# Totara & Kawaka Streets

## Scheme design stage safety audit

Report prepared for  
Tauranga City Council  
September 2017

Figure 5: Simple graphic indicating the possible extent of the overrun at driveway 9  
 This could create an ongoing maintenance problem. It is also possible that this will create a hazard, with bits of broken separator obstructing the cycleway.

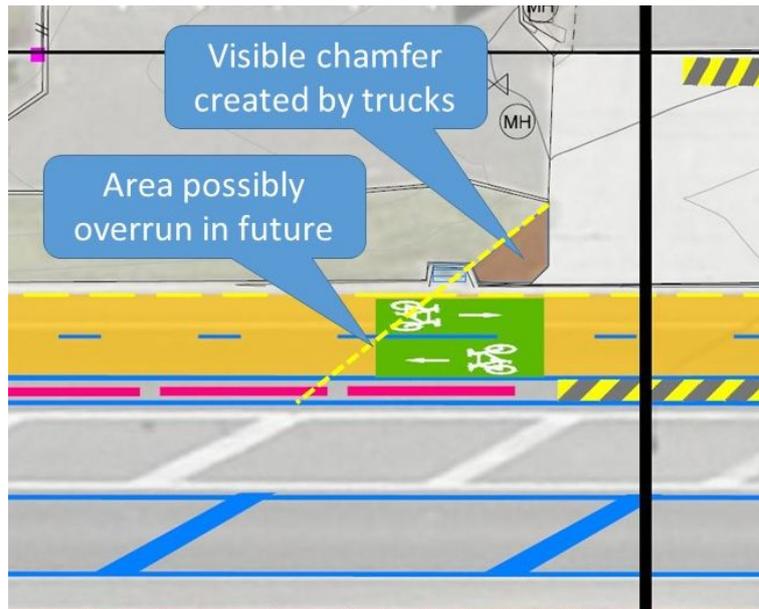
The problem is that the geometric design of the driveways appears to be based on the assumption that truck drivers will turn into the driveway without running over the berm like at present, and that larger trucks swing wide onto the flush median, as no swept path allowance appears to have been made. This will not work like that in practice, but it is likely that truck drivers will overrun the proposed separators, just as they currently mount the kerb.

- 2.1.5.1.** Undertake geometric design of each driveway based on a design vehicle appropriate for each driveway.

Figure 7: Placement of markings at driveways

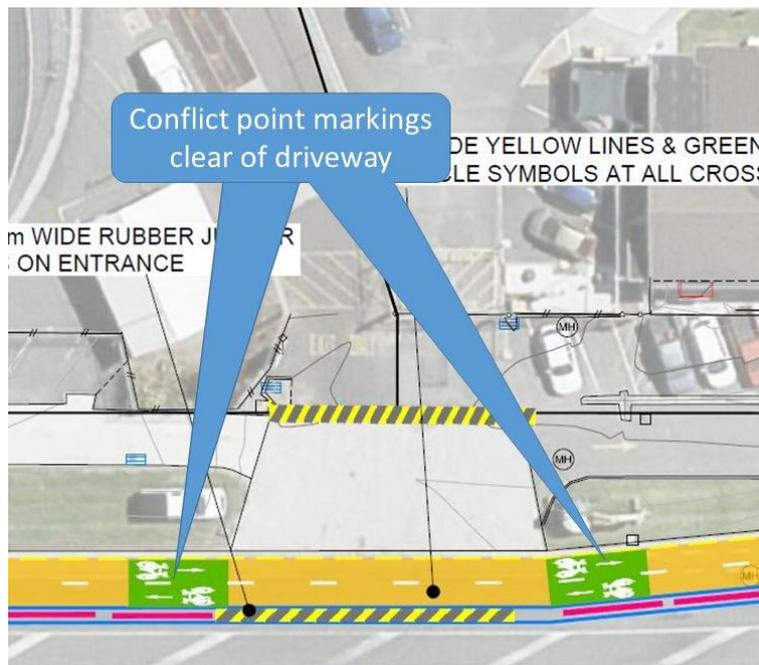
The scheme proposes white cycle logos and directional arrows on top of green coloured boxes at driveways. These markings are proposed to be placed just clear of driveways, presumably to minimise maintenance costs (see Figure 7). Convention is to place these markings directly at the conflict point so that their safety impact (i.e. reminding drivers that they are crossing a cycle facility) is maximised.

Placing the markings away from the conflict point will make them less conspicuous to drivers and therefore increase the risk of collision between vehicles and people on bikes, especially those in the contra-flow (unexpected) direction. This is expected to result in occasional crashes. Such crashes that do occur are likely to result in death or serious injury. Therefore, the overall safety rating is moderate.

| <b>2.1.7.1.</b>           | Place the driveway markings directly at the conflict point. |

Figure 8: Potential vehicle tracking that avoids the chicane for a ‘quick exit’

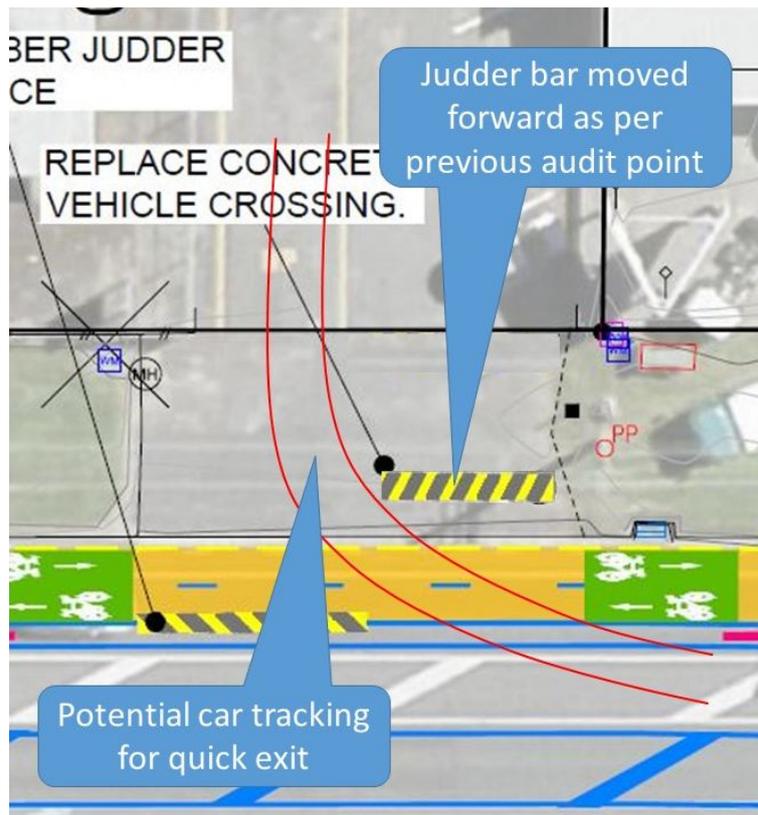
At some of the driveways, the judder bars are placed in a way that drivers exiting to their left, or driving entering to their right, could avoid the vertical deflection. This is conceptually shown in Figure 8, which uses driveway 21 as the example location (note that the judder bar for exiting vehicles has been shifted closer to the cycleway as per section 2.1.6.1 – the problem still exists even then).

Exiting drivers, for example, may concentrate on whether other drivers are turning into the driveway, and if their way is clear and they can see a gap to turn into, they may adopt a tracking path that completely avoids the judder bars, as shown in the figure. When drivers are making these decisions in quick succession, they may well have forgotten that they should also check for cycleway users. Once again, those users travelling in a contra-flow direction are most at risk of getting overlooked, as the exiting driver would have glanced the other way to identify a suitable gap in the northbound traffic.

Crashes resulting from this behaviour can be expected to occur occasionally. Given the speed involved, such crashes are very likely to result in death or serious injury. Therefore, the overall safety rating is significant.

**2.1.8.1.** Make the judder bars long enough to prevent this behaviour from occurring; consider extending them across the whole width of the driveways.

Figure 9: Angle parking (driveway 19) is set to remain

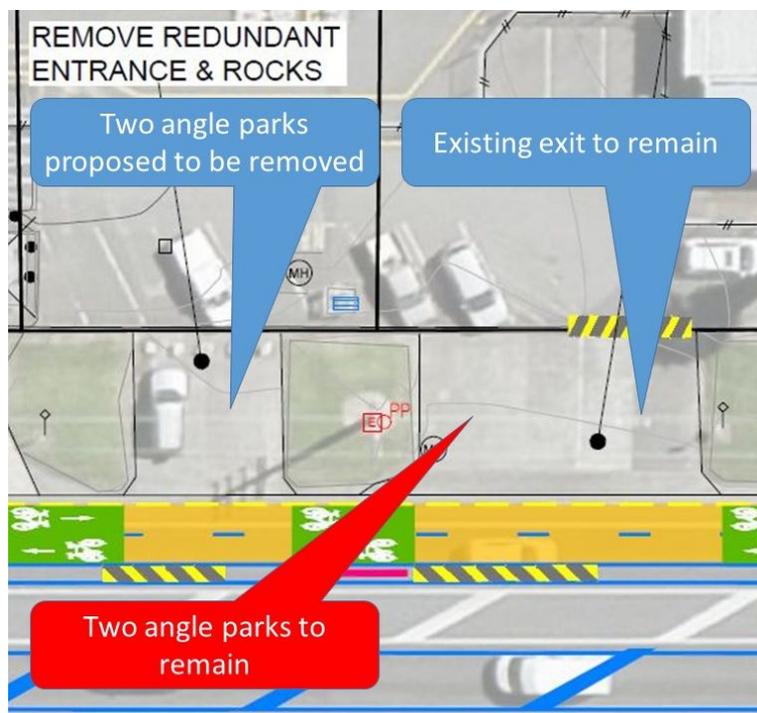
There are two locations outside Ixom that are used for angle parking; driveways 18 and 19 as per section 1.13. Both appear to be previous driveways, with driveway 18 no longer in use, and driveway 19 previously being combined with the adjacent driveway 20 providing one generously-dimensioned facility. The scheme design proposes the removal of driveway 18, while the two angle parks at driveway 19 are to remain. The situation is shown in Figure 9.

It is inappropriate to require drivers to reverse into a busy arterial road like Totara Street. It is even more inappropriate to require them to back across a two-way cycleway while doing so. This puts people cycling at risk, and is hazardous for the reversing drivers, too.

Crashes resulting from reversing may be infrequent. Crashes that do occur are unlikely to result in death or serious injury. Therefore, the overall safety rating is minor.

**2.1.9.1.** Remove the two existing angle parks that are marked at driveway 19.

Figure 14: Unnecessary widening on the approach to Hewletts Road

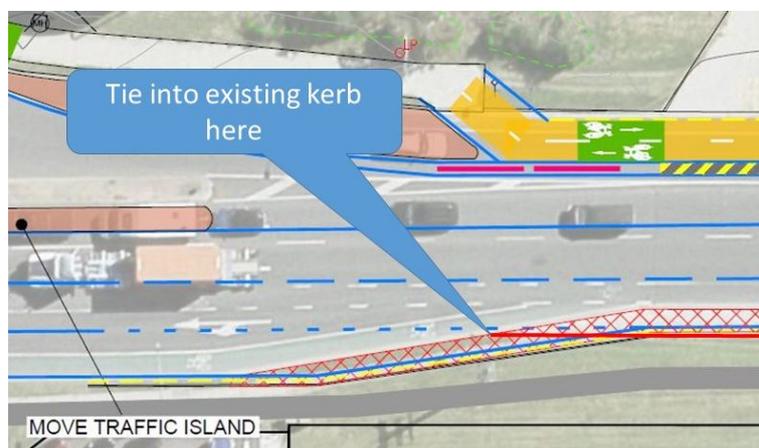
The proposed lengthening of the kerbside lane on the approach to Hewletts Road shown in Figure 14 is an expensive change for which the reason for doing so is not evident. During most of the day, long queues can be observed on this approach and the kerbside lane becomes available only after the Totara Street approach has a green light; making the lane slightly longer will make no difference to intersection performance.

Figure 18: Missing cycleway separator

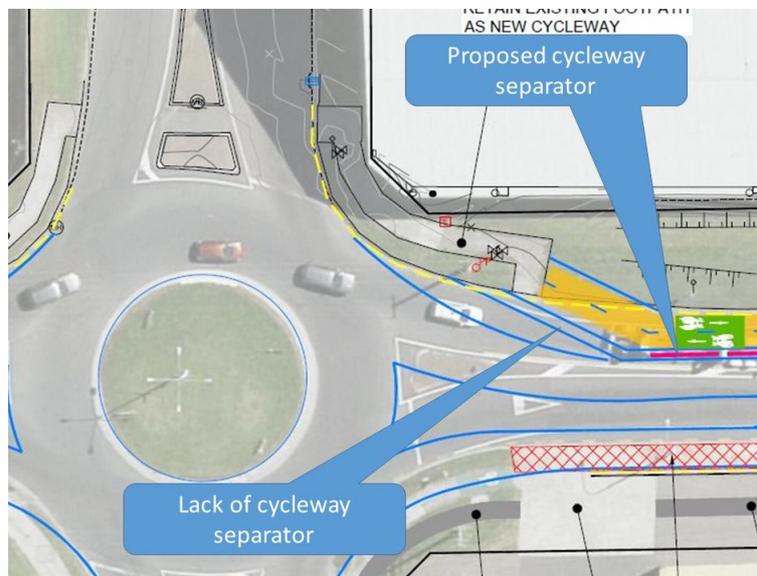
North of the roundabout with Hull Road, the proposed cycleway continues on the west side of the carriageway, separated from motor traffic with a proposed separator. As is shown in Figure 18, there is no separator where the cycleway transitions from the berm onto the carriageway. The alignment for drivers is such that they may inadvertently drive into the cycleway, instead of remaining on the carriageway.

This may result in occasional crashes between people cycling and motor vehicles. Such crashes are likely to result in death or serious injury. Therefore, the overall safety rating is moderate.

- 2.2.6.1.** Provide a cycleway separator north of the Hull Road roundabout so that drivers don't inadvertently drive onto the cycleway. Leave a sufficient gap so that any cyclists circulating within the roundabout can join the proposed facility.

Figure 21: Intervisibility should be ensured for yellow areas

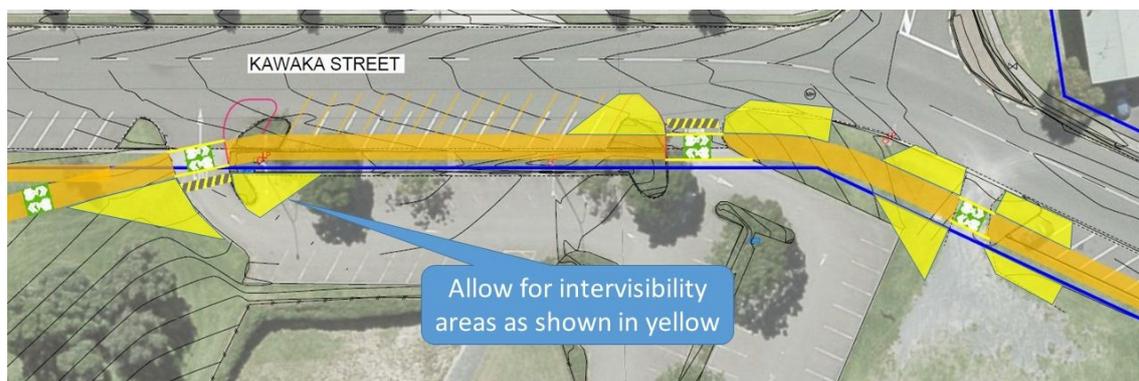
Given the parking demand at Blake Park observed during the site visits, it is clear that the driveways into and out of the Blake Park car parks will be busy. As explained elsewhere in this report, the most at-risk people are those cycling in a contraflow direction, i.e. in this case in an eastbound direction. That said, it is necessary to provide good intervisibility at and before the crossing points for cycle travel in both directions. It will be challenging to keep visibility splays unobstructed from informal parking, and it will be necessary to employ passive means like low landscaping, link and chain fences, or high kerbs. The yellow areas in Figure 21 may be those that need further consideration. This is based on our observations that the two western driveways operate as one-way, whilst the eastern one (shown in Figure 11) operates in both directions.

Consideration should also be given as to whether a judder bar is a sufficient calming measure, or whether a raised platform with reasonably short ramps could be more effective. We note that the eastern driveway does not appear to have received any treatment. The western exit, for example, could be squared up as part of this project, to further slow down drivers.

The interaction between people driving and cycling at driveways is often the primary safety issue for pathway projects. Crashes of this nature can be expected to be common, but they are unlikely to result in death or serious injury. Therefore, the overall safety rating is moderate.

Figure 22: Tawa Street platform should support pedestrian desire line

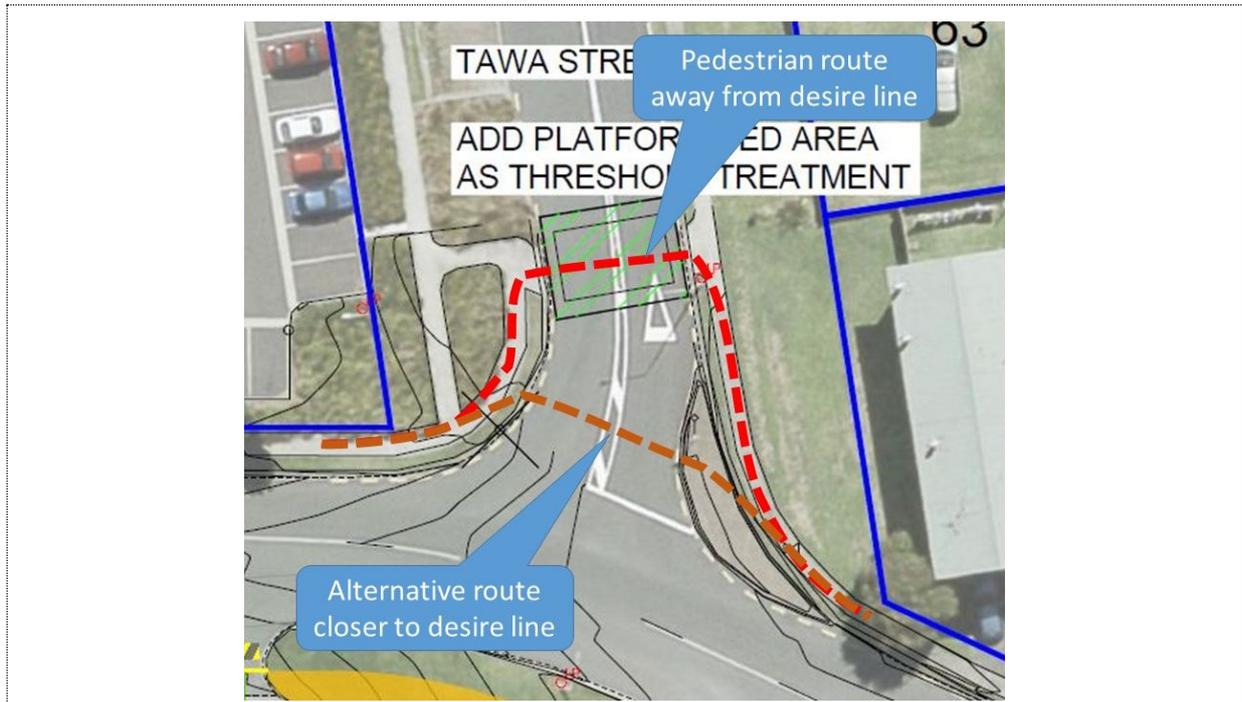
| The platform proposed for Tawa Street creates a circuitous route for pedestrians who want to walk along Kawaka Street. Figure 22 below shows a more logical route that should be allowed for as an alternative to the proposed detour. |

**2.3.3.1.** Provide a platform in Tawa Street that supports the pedestrian desire line.
